SERVICE BULLETIN

N° 189-188

ATA 30 – WIPERS AND WINDSHIELD WASHING KIT

This Service Bulletin is issued in order to provide the necessary instructions on how to perform the installation of the kit wiper for glass windshield P/N 8G3040F00311 and kit windshield washing P/N 8G3040F00211.

Figure 1

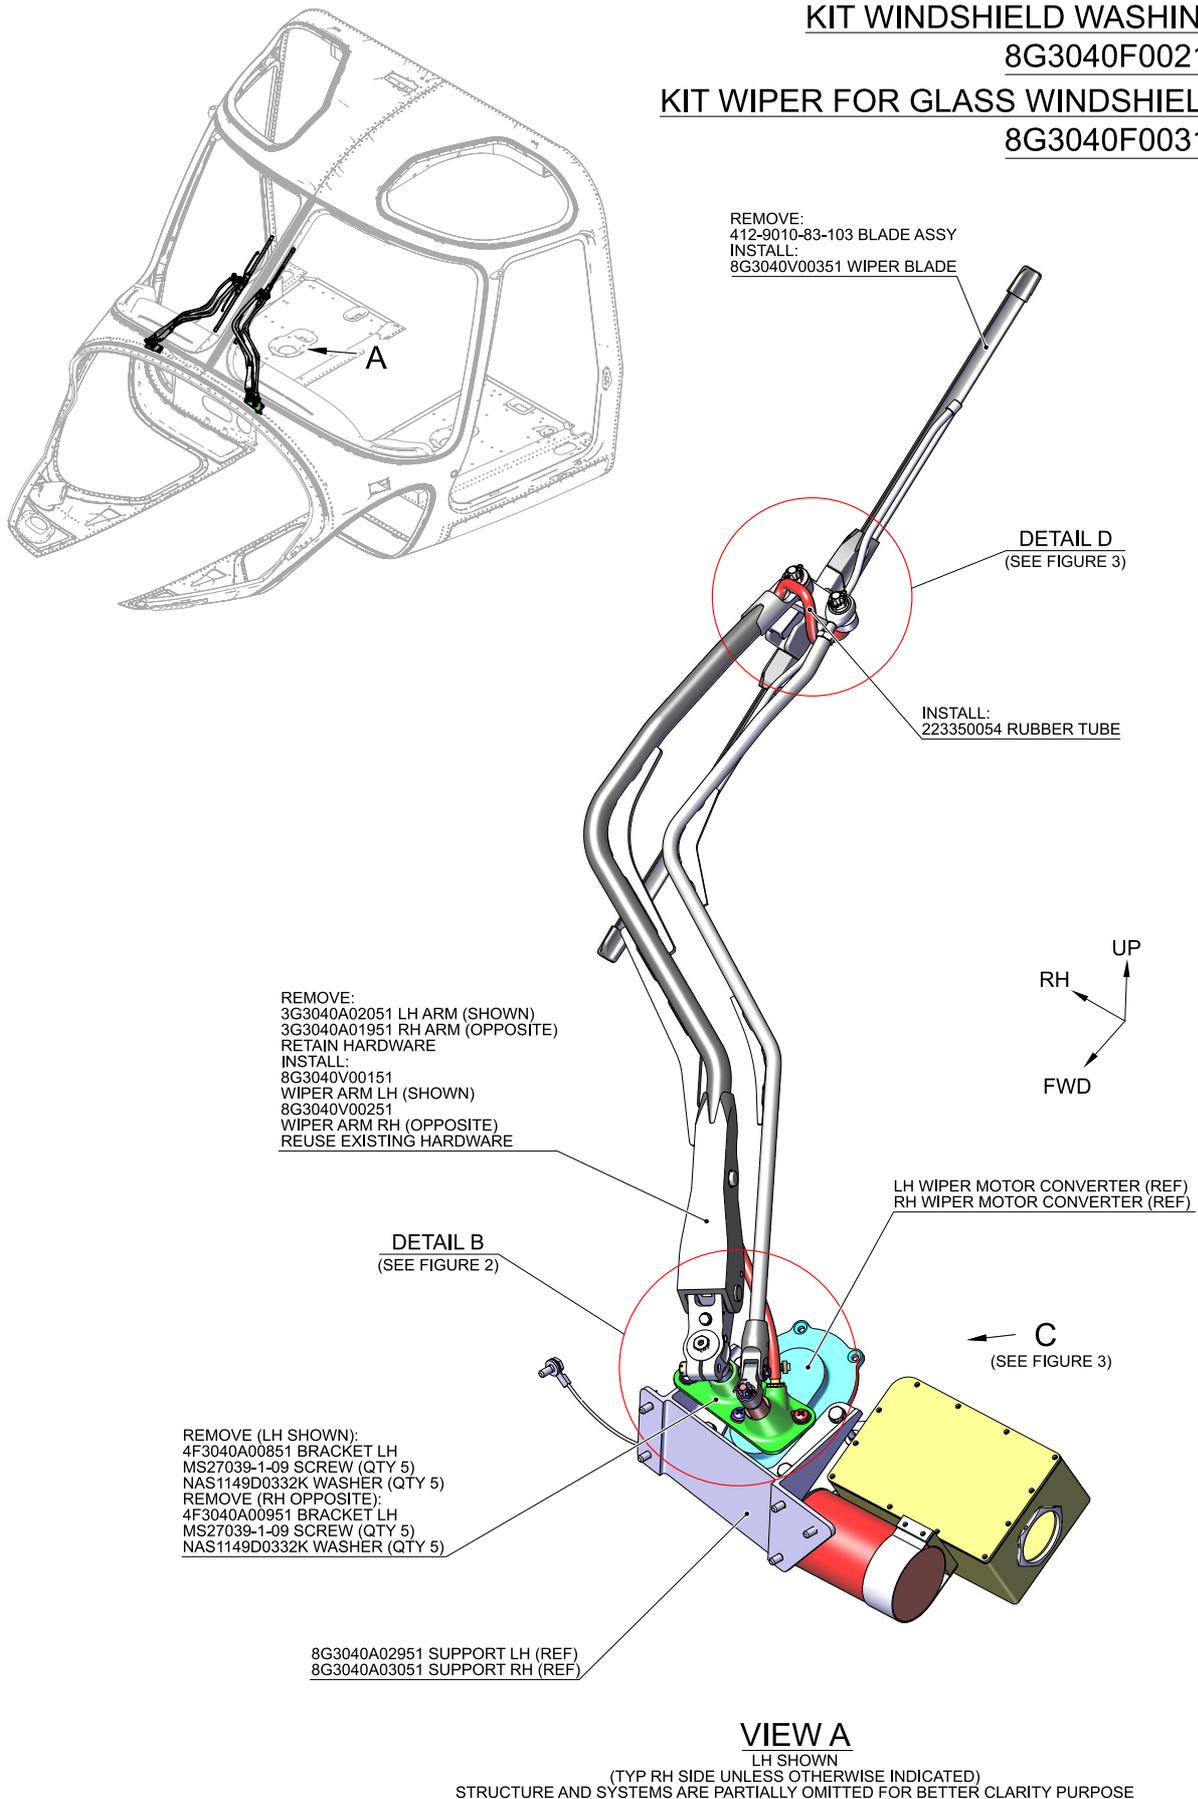
- 2.1 In accordance with the applicable steps of AMP DM 89-A-30-42-04-00A-920A-A and with reference to Figure 1 View A, remove the RH blade assy P/N 412-9010-83-103 from the RH arm P/N 3G3040A01951.

- 2.2 In accordance with the applicable steps of AMP DM 89-A-30-42-05-00A-920A-A and with reference to Figure 1 View A, remove the left blade assy P/N 412-9010-83-103 from the LH arm P/N 3G3040A02051.

- 2.3 In accordance with AMP DM 89-A-30-42-06-00A-520A-A and with reference to Figure 1 View A, remove the RH arm P/N 3G3040A01951. Retain hardware for later reuse.

- 2.4 In accordance with AMP DM 89-A-30-42-07-00A-520A-A and with reference to Figure 1 View A, remove the LH arm P/N 3G3040A02051. Retain hardware for later reuse.

- 2.9 With reference to Figure 1 View A, remove the bracket LH P/N 4F3040A00851, n°5 screws P/N MS27039-1-09 and n°5 washers P/N NAS1149D0332K.
- 2.10 With reference to Figure 1 View A, remove the bracket RH P/N 4F3040A00951, n°5 screws P/N MS27039-1-09 and n°5 washers P/N NAS1149D0332K.

- 3.6 In accordance with the applicable steps of AMP DM 89-B-30-42-05-00A-920A-A and with reference to Figure 1 View A and Figure 3 Detail D, install the wiper blade P/N 8G3040V00351 on the wiper arm LH P/N 8G3040V00151.

- 3.7 In accordance with AMP DM 89-B-30-42-07-00A-720A-A and with reference to Figure 1 View A and Figure 2 Detail B and Section E-E, install the wiper arm LH P/N 8G3040V00151 and adjust the wiper arm and blade park position.

- 4.2 With reference to Figure 1 View A and Figure 3 Detail D and View C, insert the rubber tube P/N 223350054 into the wiper arm LH P/N 8G3040V00151 and

Figure 2

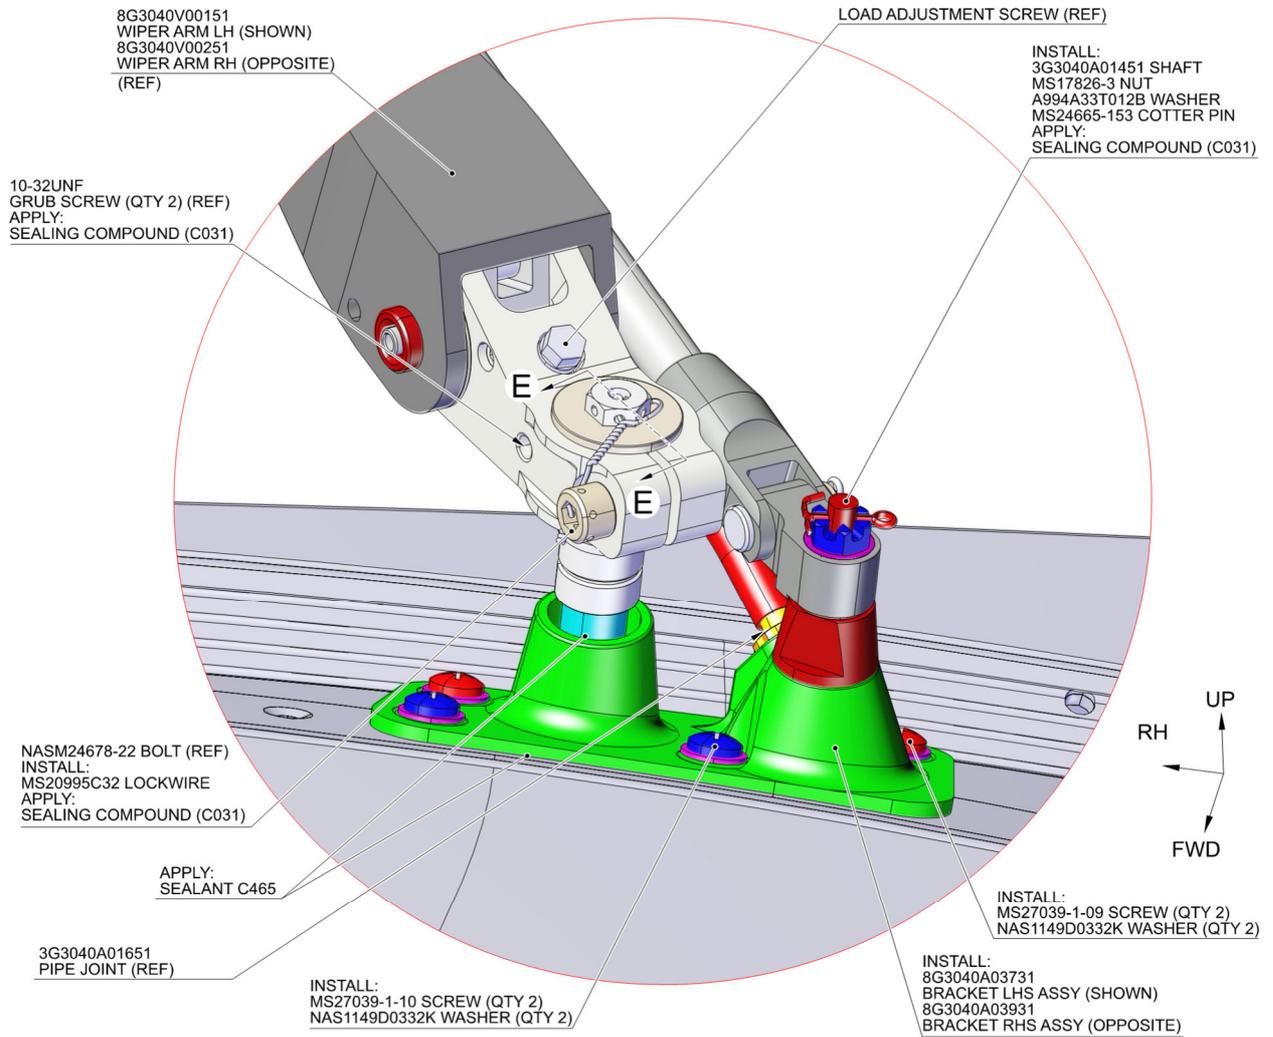
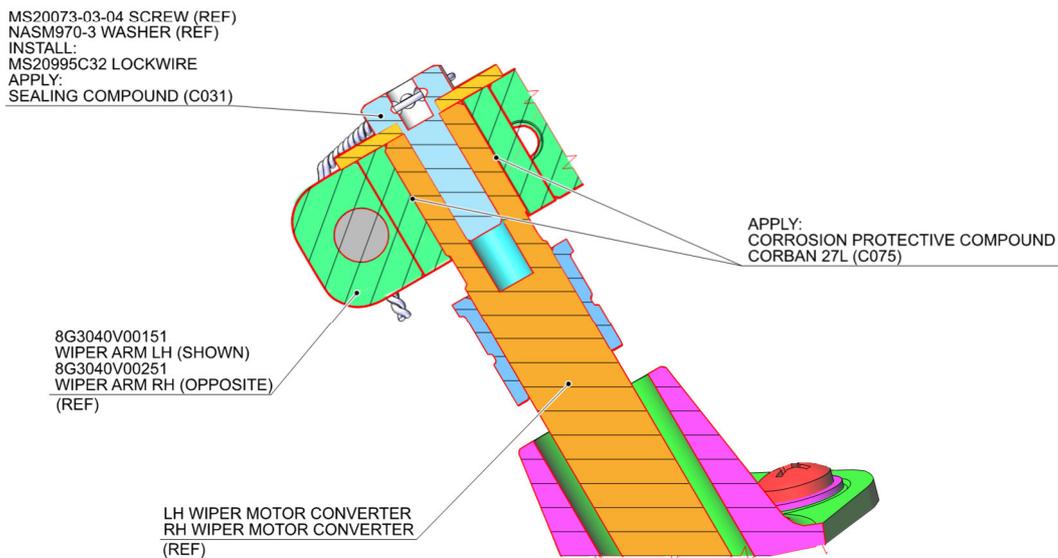
- 3.1 With reference to Figure 2 Detail B, install the bracket LHS assy P/N 8G3040A03731 in position on the structure LH side by means of n°2 screws P/N MS27039-1-09, n°2 screws P/N MS27039-1-10 and n°4 washers P/N NAS1149D0332K.

- 3.5 With reference to Figure 2 Detail B, install the shaft P/N 3G3040A01451 in its housing on the bracket LHS assy P/N 8G3040A03731.

Before installation, apply on the motor shaft splined end corrosion protective compound Corban 27L C075 (refer to Figure 2 Section E-E).

Figure 3

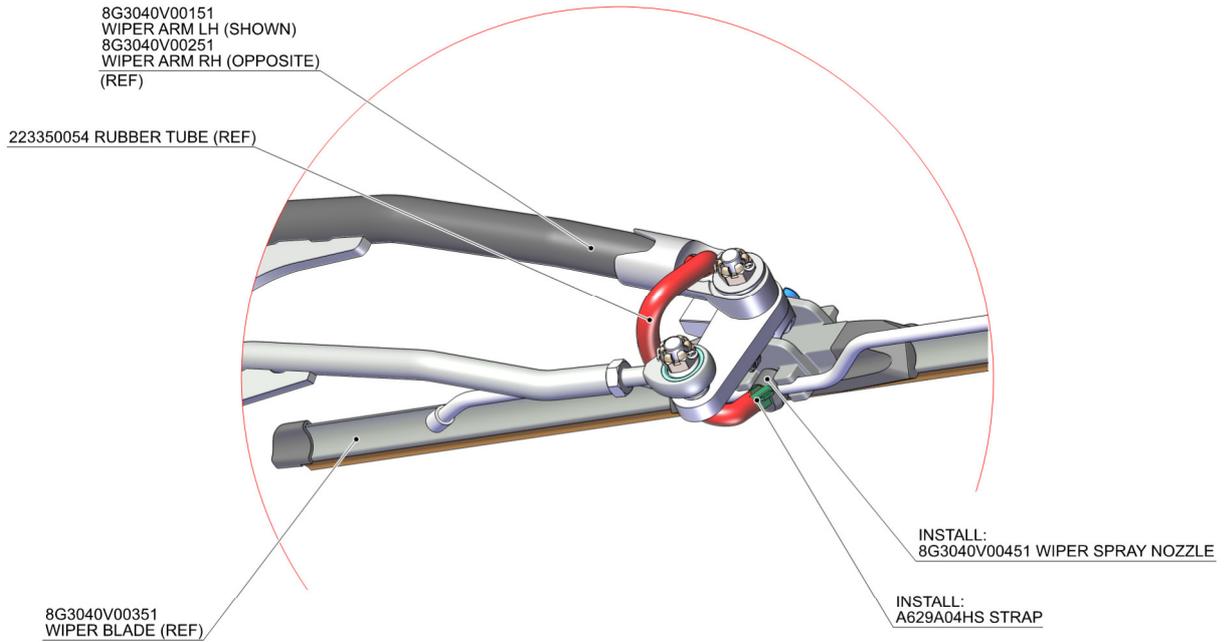
- 2.5 With reference to Figure 3 View C, remove and retain the pipe joint P/N 3G3040A01651 from the bracket LH P/N 4F3040A00851 (upper side).
- 2.6 With reference to Figure 3 View C, loose the strap P/N A629A04HS and disconnect the rubber tube P/N 223350054 from the pipe joint P/N 3G3040A01651 on the bracket. Remove and retain the pipe joint from the bracket LH P/N 4F3040A00851 (lower side).

- 2.7 With reference to Figure 3 View C, remove and retain the pipe joint P/N 3G3040A01651 from the bracket RH P/N 4F3040A00951 (upper side).
- 2.8 With reference to Figure 3 View C, loose the strap P/N A629A04HS and disconnect the rubber tube P/N 223350054 from the pipe joint P/N 3G3040A01651 on the bracket. Remove and retain the pipe joint from the bracket RH P/N 4F3040A00951 (lower side).

- 3.2 With reference to Figure 3 View C, re-install the pipe joint P/N 3G3040A01651 (lower side) previously removed on the bracket LHS assy P/N 8G3040A03731 by means of adhesive sealant C465.

- 3.3 With reference to Figure 3 View C, re-connect the rubber tube P/N 223350054 to the pipe joint P/N 3G3040A01651 by means of the strap P/N A629A04HS.

- 3.4 With reference to Figure 3 View C, re-install the pipe joint P/N 3G3040A01651 (upper side) previously removed on the bracket LHS assy P/N 8G3040A03731 by means of sealant C465.

- 4.1 With reference to Figure 3 Detail D, install the wiper spray nozzle P/N 8G3040V00451 on the left wiper blade P/N 8G3040V00351 by means of the nut and the cotter pin (hardware is part of P/N 8G3040V00451).

Figure 4

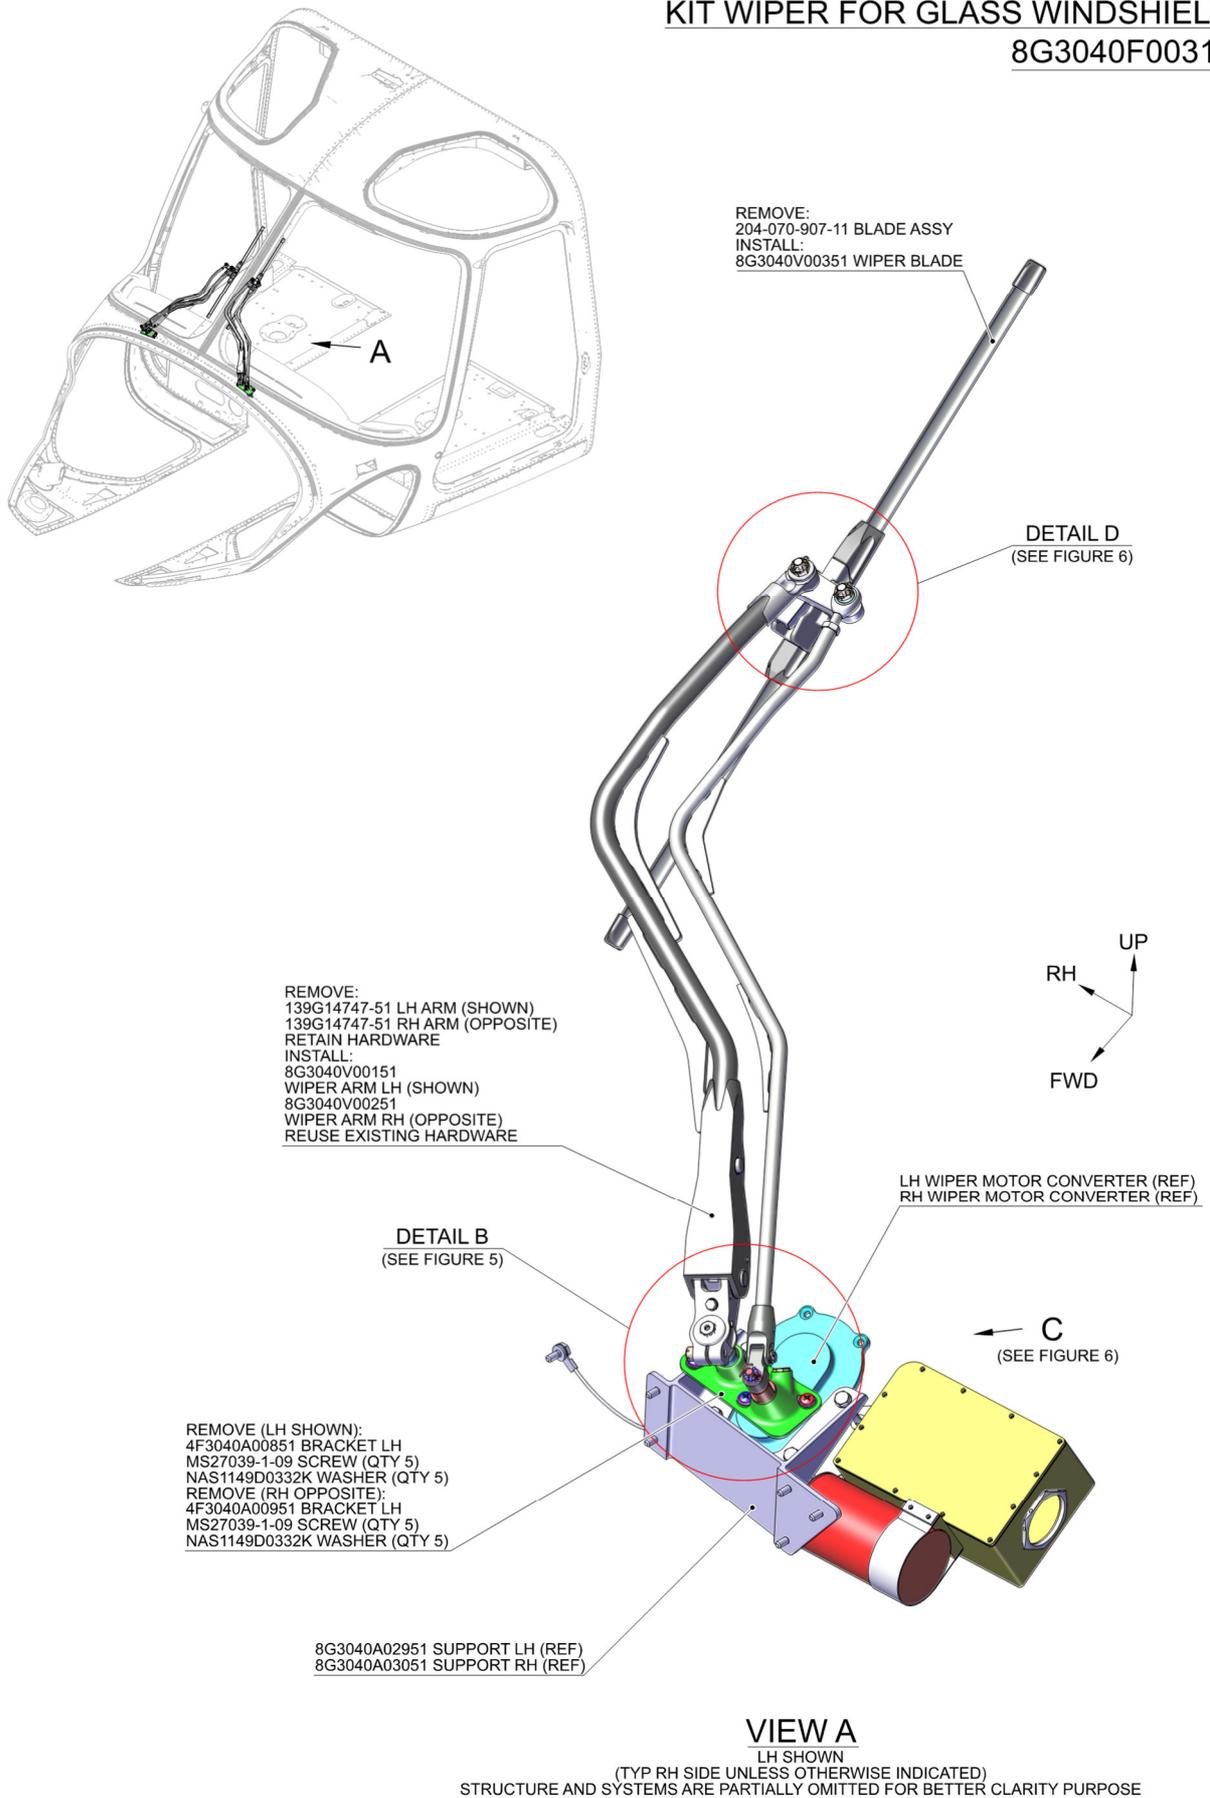
- 2.1 In accordance with the applicable steps of AMP DM 89-A-30-41-01-00A-920A-A and with reference to Figure 4 View A, remove the RH blade assy P/N 204-070-907-11 from the RH arm P/N 139G14747-51.

- 2.2 In accordance with the applicable steps of AMP DM 89-A-30-41-02-00A-920A-A and with reference to Figure 4 View A, remove the LH blade assy P/N 204-070-907-11 from the LH arm P/N 139G14747-51.

- 2.3 In accordance with AMP DM 89-A-30-41-03-00A-520A-A and with reference to Figure 4 View A, remove the RH arm P/N 139G14747-51. Retain hardware for later reuse.

- 2.4 In accordance with AMP DM 89-A-30-41-04-00A-520A-A and with reference to Figure 4 View A, remove the LH arm P/N 139G14747-51. Retain hardware for later reuse.

- 2.7 With reference to Figure 4 View A, remove the bracket LH P/N 4F3040A00851, n°5 screws P/N MS27039-1-09 and n°5 washers P/N NAS1149D0332K.
 - 2.8 With reference to Figure 4 View A, remove the bracket RH P/N 4F3040A00951, n°5 screws P/N MS27039-1-09 and n°5 washers P/N NAS1149D0332K.

- 3.4 In accordance with the applicable steps of AMP DM 89-B-30-41-02-00A-920A-A and with reference to Figure 4 View A and Figure 6 Detail D, install the wiper blade P/N 8G3040V00351 on the wiper arm LH P/N 8G3040V00151.

- 3.5 In accordance with AMP DM 89-B-30-41-04-00A-720A-A and with reference to Figure 4 View A and Figure 5 Detail B and Section E-E, install the wiper arm LH P/N 8G3040V00151 and adjust the wiper arm and blade park position.

Figure 5

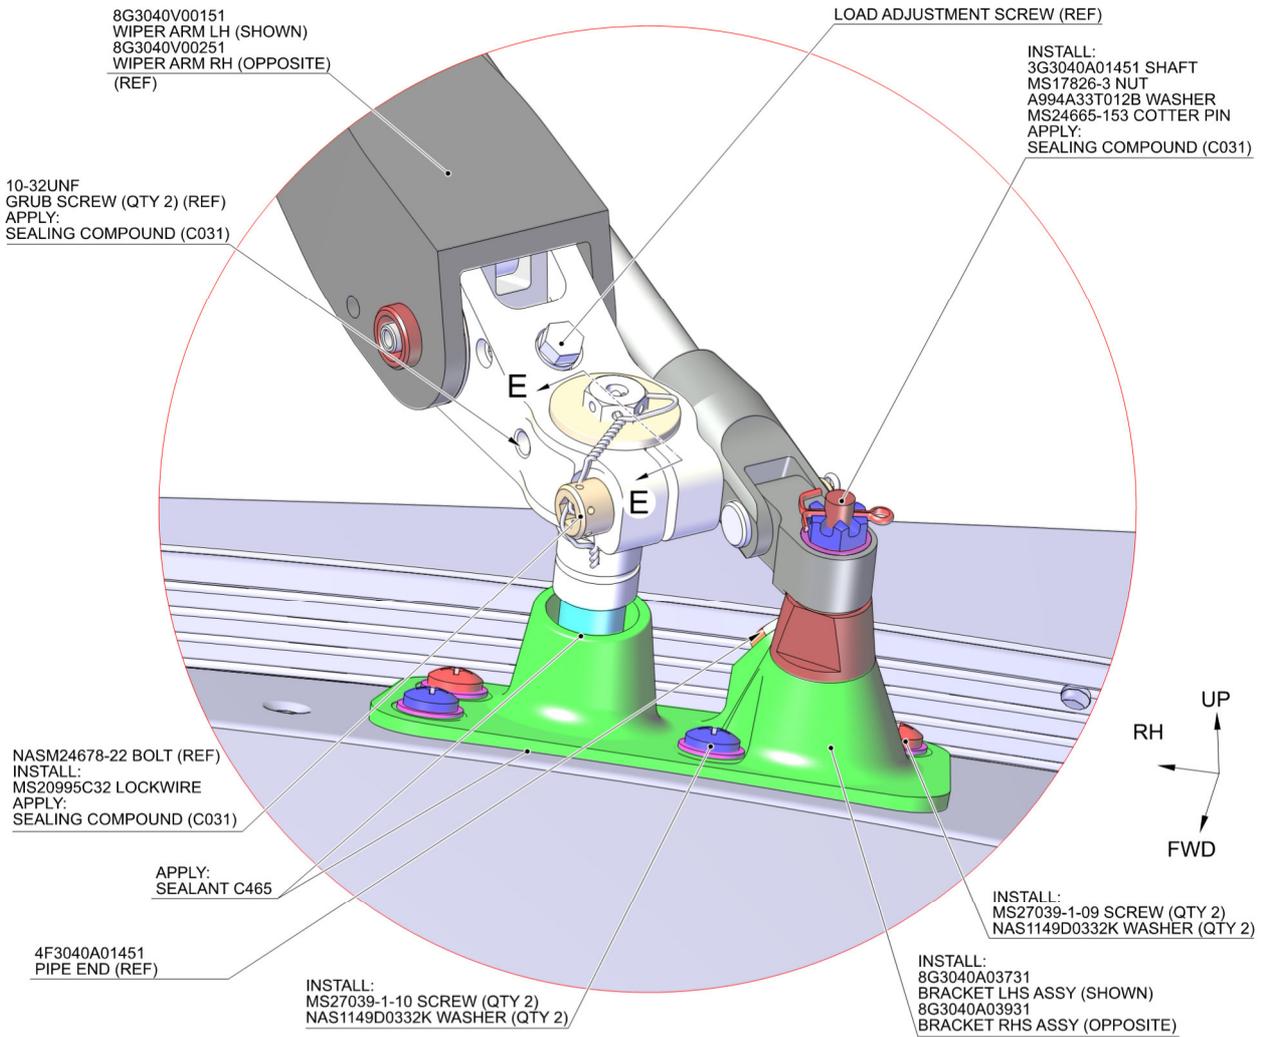
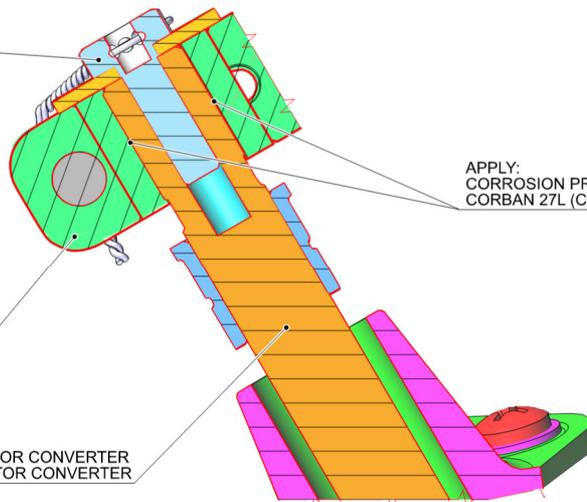
- 3.1 With reference to Figure 5 Detail B, install the bracket LHS assy P/N 8G3040A03731 in position on the structure LH side by means of n°2 screws P/N MS27039-1-09, n°2 screws P/N MS27039-1-10 and n°4 washers P/N NAS1149D0332K.

- 3.3 With reference to Figure 5 Detail B, install the shaft P/N 3G3040A01451 in its housing on the bracket LHS assy P/N 8G3040A03731.

Before installation, apply on the motor shaft splined end corrosion protective compound Corban 27L C075 (refer to Figure 5 Section E-E).
